Discussion on Maintenance Comment 201 & 202

(<https://www.802-1.org/items/318> & 317)

Tongtong Wang

Huawei Technologies

Comment 201 : 802.1Qbv Tick granularity

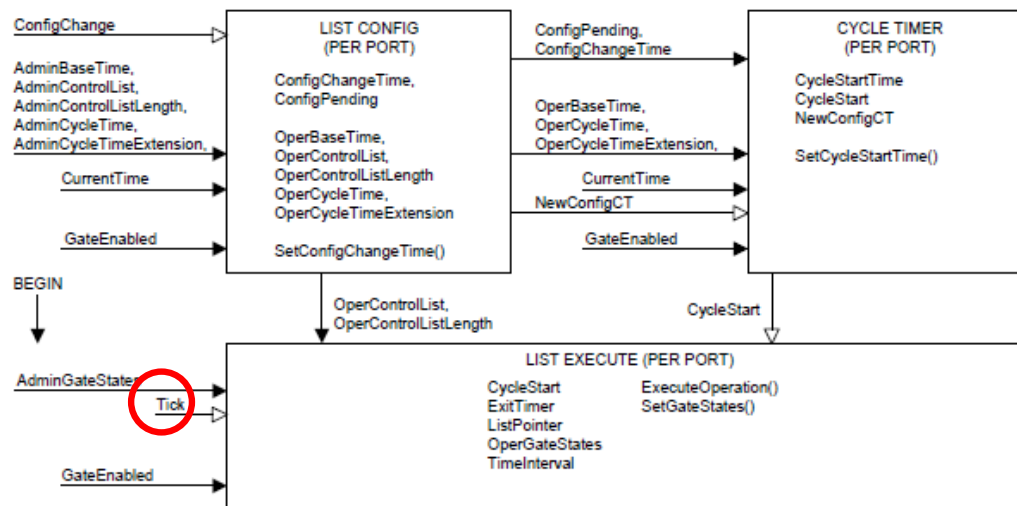
- Tick input List execute FSM as time_unit signal;

- Tickgranularity is the absolute time length for one tick;

Tick granularity is used to compute timeInterval/adminCycleTime length and set TAS time gate accordingly.

Use Case with Different Tick Granularity

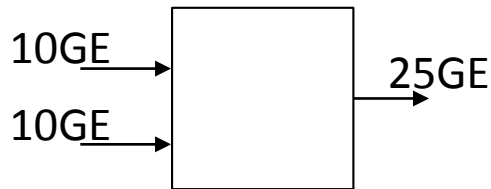
- Use case 1: aggregate flows from multiple port to one

- Tick granularity is only valid on egress port;
- Make TAS schedule for flow 1 & 2 according to TSpec

- Use case 2: schedule one flow over multiple device w/ different port rate

- Tick granularity are different on each device;
- Make TAS schedule on each egress port according to TSpec

No need to care uniform tick granularity for multiple port rate.

Qbv ConfigChangeError counter incremented incorrectly

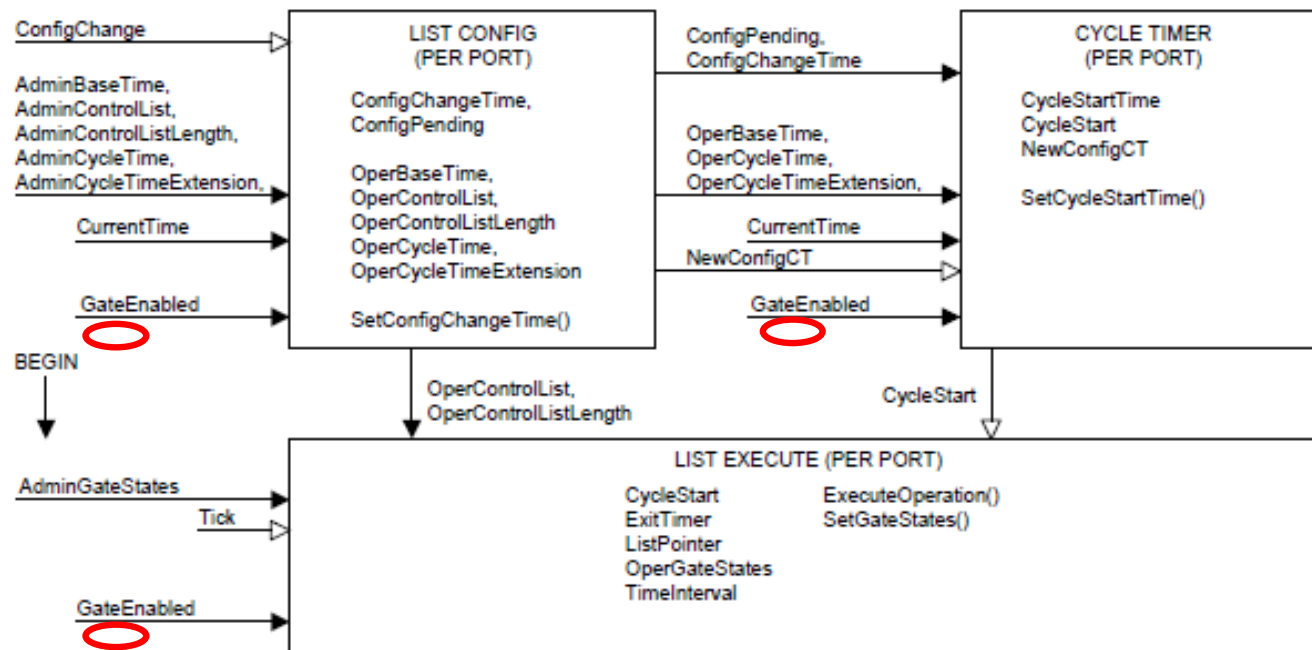
- GateEnable signal input to all three Qbv FSMs;

Figure 8-16—List Config state machine

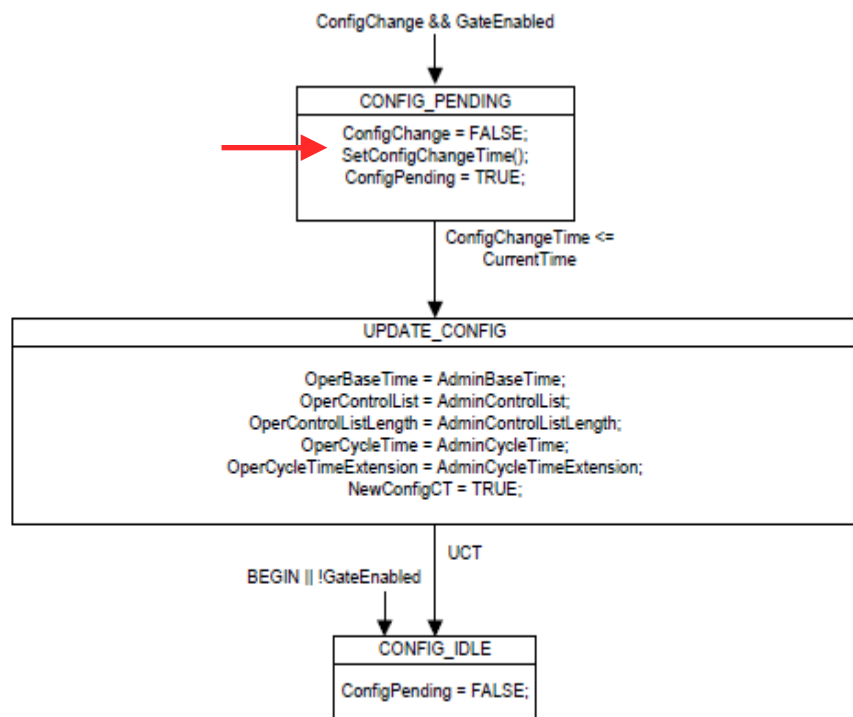
- If:
 $\text{AdminBaseTime} \geq \text{CurrentTime}$ (8.6.9.4.10)
 (i.e., AdminBaseTime specifies the current time or a future time)
 Then:
 $\text{ConfigChangeTime} = \text{AdminBaseTime}$

- If:
 $(\text{AdminBaseTime} < \text{CurrentTime})$ and $(\text{GateEnabled} = \text{FALSE})$
 (i.e., AdminBaseTime specifies a time in the past, and the current schedule is stopped)
 Then:
 $\text{ConfigChangeTime} = (\text{AdminBaseTime} + N * \text{AdminCycleTime})$
 where N is the smallest integer for which the relation
 $\text{ConfigChangeTime} \geq \text{CurrentTime}$
 would be TRUE.

- If:
 $(\text{AdminBaseTime} < \text{CurrentTime})$ and $(\text{GateEnabled} = \text{TRUE})$
 (i.e., AdminBaseTime specifies a time in the past, and the current schedule is running)
 Then:
Increment ConfigChangeError counter (12.29.1)
 $\text{ConfigChangeTime} = (\text{AdminBaseTime} + N * \text{AdminCycleTime})$
 where N is the smallest integer for which the relation
 $\text{ConfigChangeTime} \geq \text{CurrentTime}$
 would be TRUE.

- DISCUSS:

- This erroneous scenario happens only when changing configuration during runtime and AdminBaseTime is mistakenly set.
 - Correct procedure for runtime reconfiguration is set Admin variables first and then set ConfigChange trigger.

Timing diagram for dynamic reconfiguration

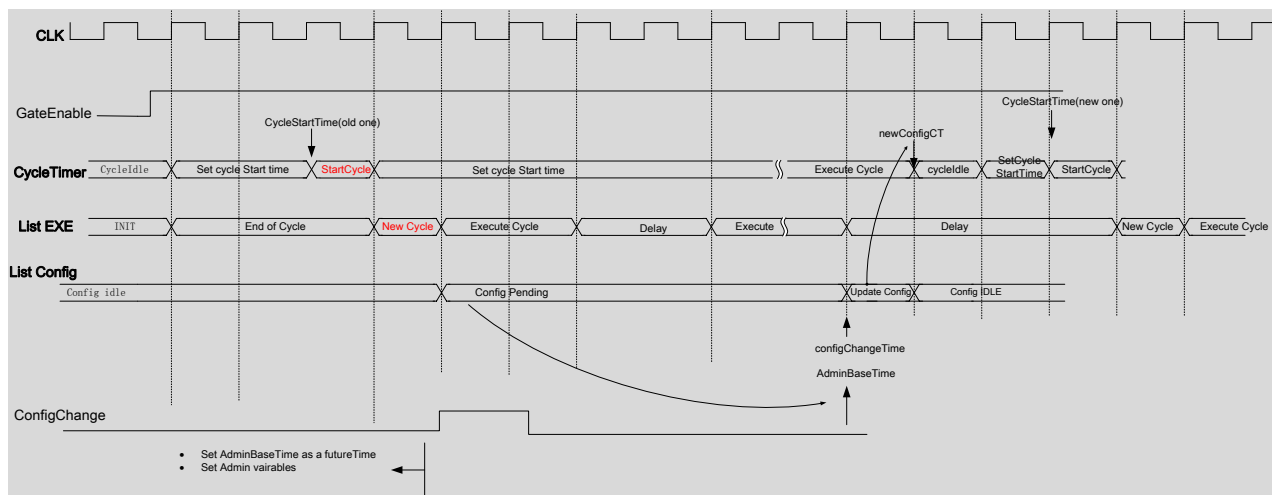
- The only requirement for dynamic reconfiguration is smooth changing, it is desirable to have no interference for stable flow schedule.
 - Small jitter is tolerable
 - More analysis is preferred on efficiency of dynamic reconfiguration, aiming for less wasted bandwidth and traffic bursts.

FSM in Standard is just procedural guidance, not cycle accurate.
